Subject: Corrections / Clarifications to the Exelon Generation company, LLC
(EGC) Early Site Permit (ESP) Application Site Safety Analysis Report
and Emergency Plan for the Clinton ESP Site (TAC No. MC1122)

U.S. Nuclear Regulatory Commission
December 7, 2004, Enclosure 1

Corrections / Clarifications to the Site Safety Analysis Report of the EGC ESP

Figure 2.4-2
Plan of Main Dam, Spillways,
and Outlet Works

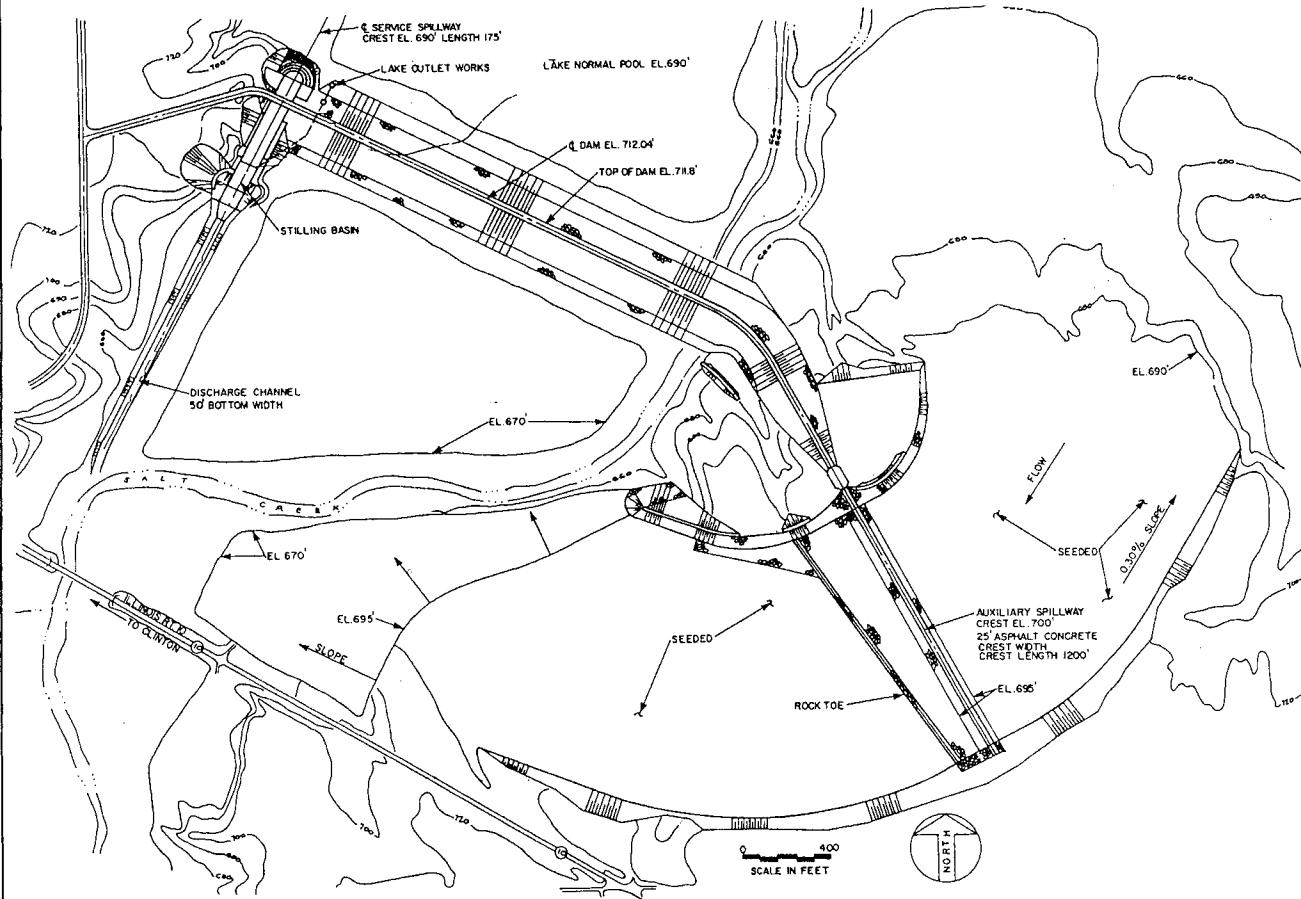
SSAR Figures 2.4-2, 2.4-10, 2.4-11, 2.4-12, 2.4-14 and 2.4-15 were revised to improve the legibility

1. Replace SSAR Chapter 2, Figures 2.4-2, 2.4-10, 2.4-11, 2.4-12, 2.4-14 and 2.4-15 with the revised figures provided in Attachment 1.

Figure 2.4-20
Location of Piezometers, CPS
Test Well, and Water Table
in Site Vicinity

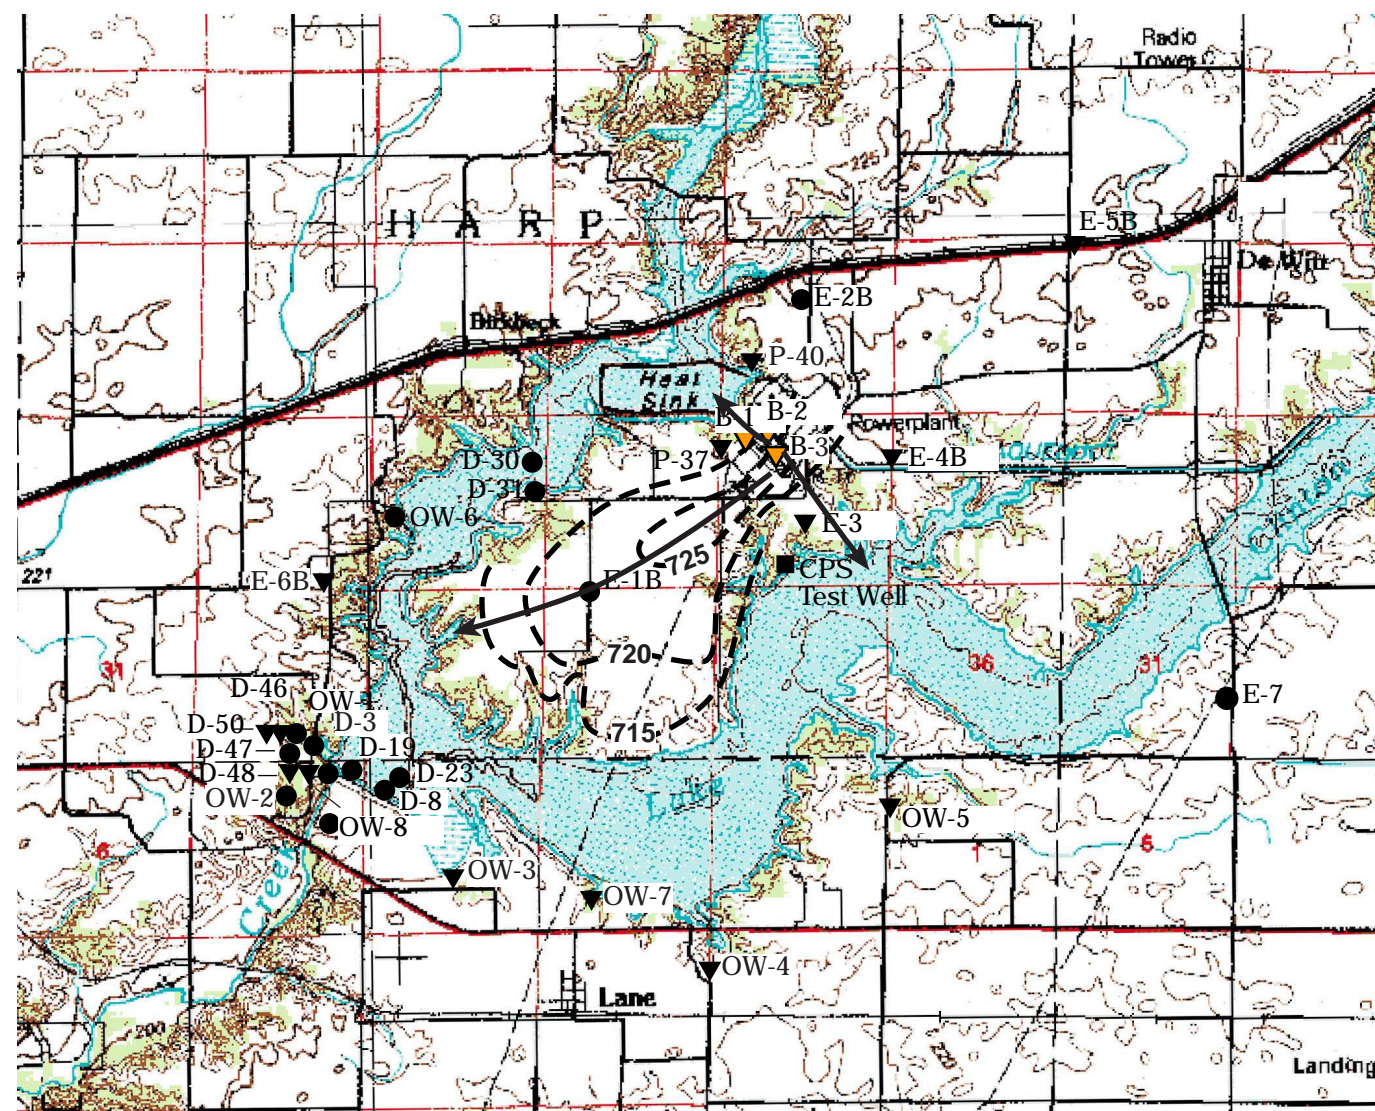
Water table elevations shown on the Figure 2.4-20 are incorrect (not consistent with the flow arrow). Elevations on figure will be modified by switching the "715" and "725" contour levels.

- 1. Replace SSAR, Chapter 2, Figure 2.4-20, with the revised figure provided in Attachment 1.*

Figure 2.4-5
Post-dam Peak Flood
Magnitudes and Frequencies for
Salt Creek at Rowell Gauge Station

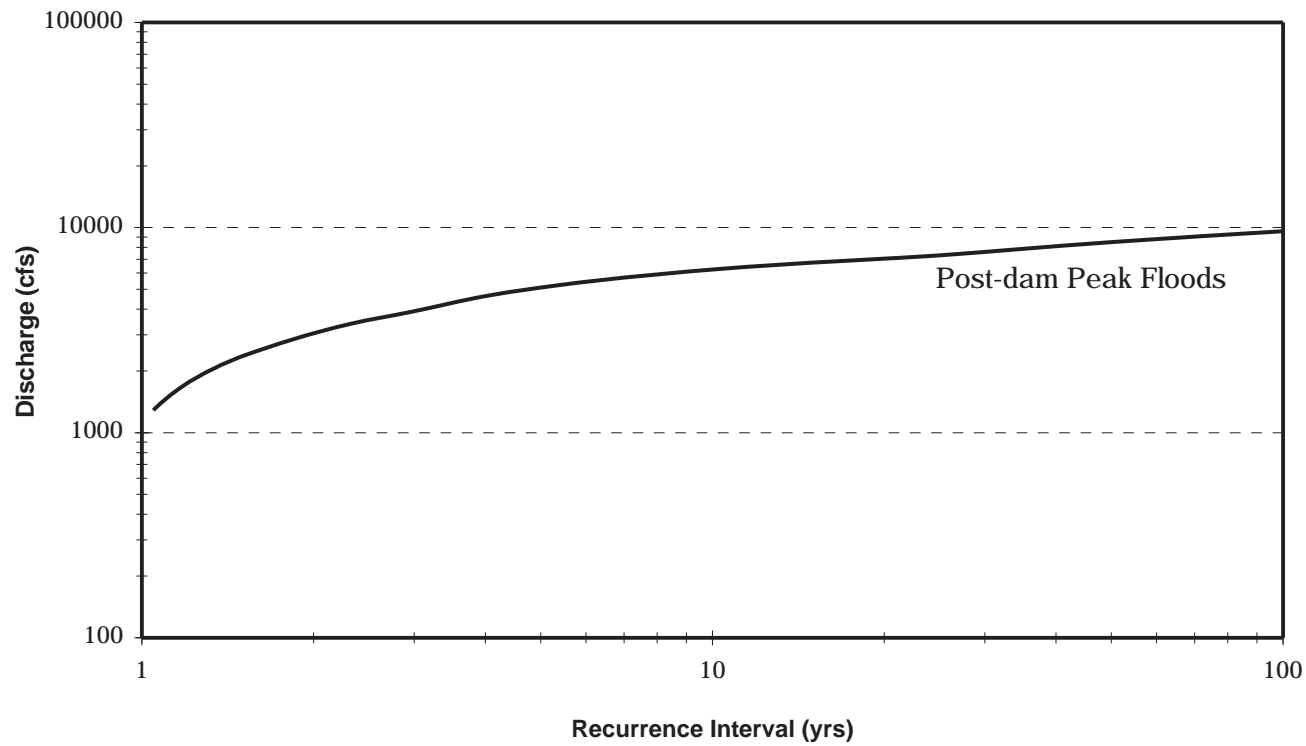
The flood frequency estimations for the Rowell gauge were re-examined (based on discussions with the NRC during their site visit and the draft RAIs where they noted discrepancies with the discharge data) resulting in an update of the statistical analysis of the historical discharge data at the Rowell gauge. First, the period of record for the historical data was updated to include Water Years 1979 through 2003. Second, the latitude and longitude of the input to the USGS DOS-based program (Peak FQ) which is the Log Pearson Type III analysis as described in WRC Bulletin 17B was revised to more closely reflect the location of the gauge. Additionally, a note is added to SSAR Figure 2.4-5 (for clarification) which reads: "Note: Based on daily mean discharge values."

3. Replace SSAR, Chapter 2, Figure 2.4-5, with the revised figure provided in Attachment 1.
